PCN: V13-002-48475412-0A

Product Change Notice

To change 5mm Lamp leadframe thickness from 25mils to 18mils.

Description and Extent of Change:

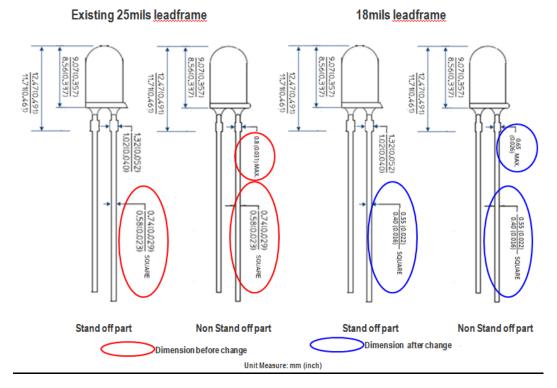
25mils leadframe thickness for existing 5mm Lamp (for above part numbers) will be replaced by 18 mils leadframe thickness. There is no change in device functionality and electrical performance.

No impact to product performance as the only difference is in the leadframe thickness. This 18mils leadframe is an existing leadframe that is being used in production for other 5mm lamp part numbers.

Recommended PC board plated through holes (PTH) size for LED component leads:

LED Component Lead Size	Diagonal	Plated Through- Hole Diameter
Lead size (typ.)	$0.45 \times 0.45 \text{ mm}$	0.636 mm	0.98 to 1.08 mm
	(0.018 × 0.018 in.)	(0.025 in)	(0.039 to 0.043 in)
Dambar shear-	0.65 mm	0.919 mm	
off area (max.)	(0.026 in)	(0.036 in)
